COMPOSITE SITE PLAN showing changes

PRELIMINARY ENGINEERING FOR THE RESIDENCES OF SOUTHBRIDGE

THE RESIDENCES OF SOUTHBRIDGE

SITE PLAN

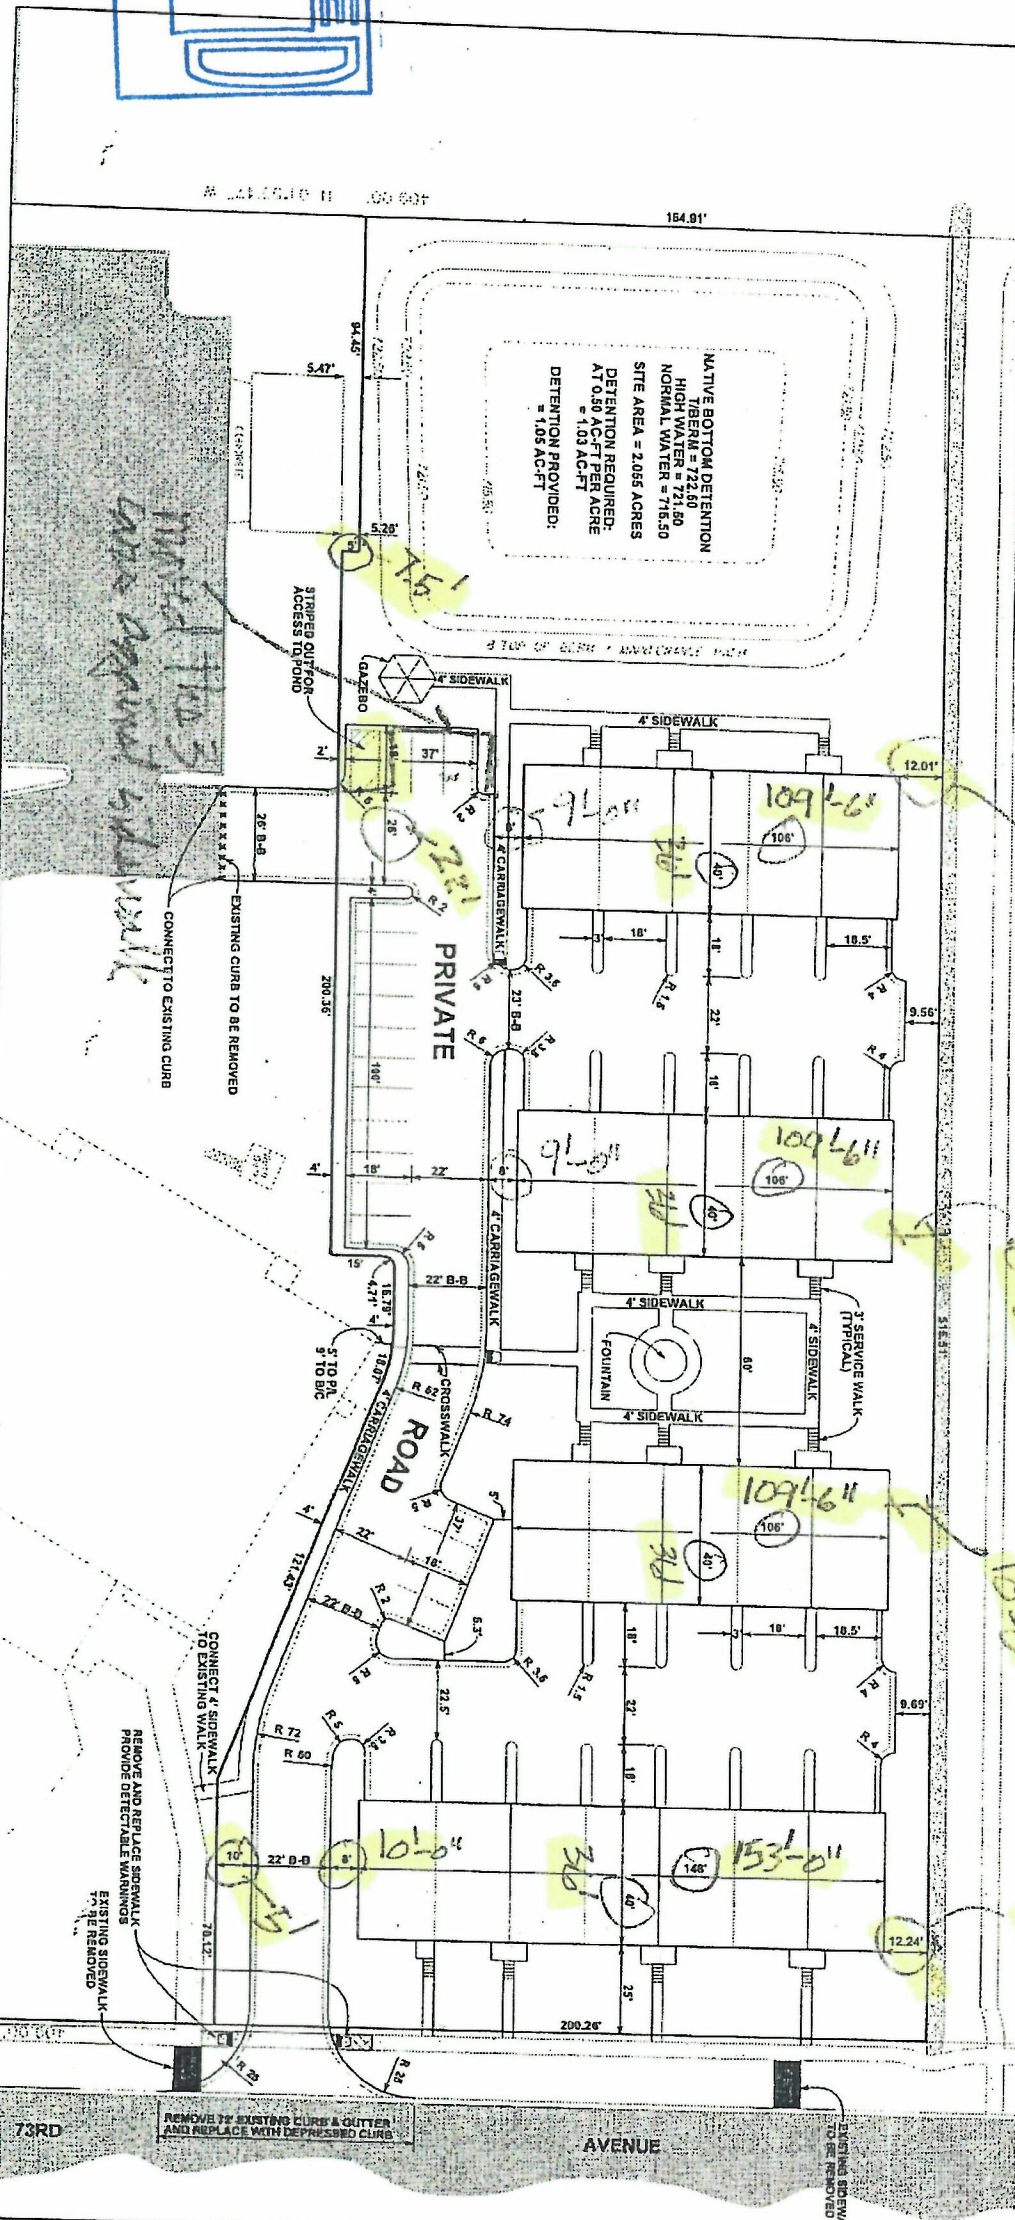
CHANGES

COMPARISON W/ REVISED SITE PLAN 9/12/14
(APPROVED SITE PLAN)

REMOVE 110'3\"/>

REMOVE 7'2\"/>
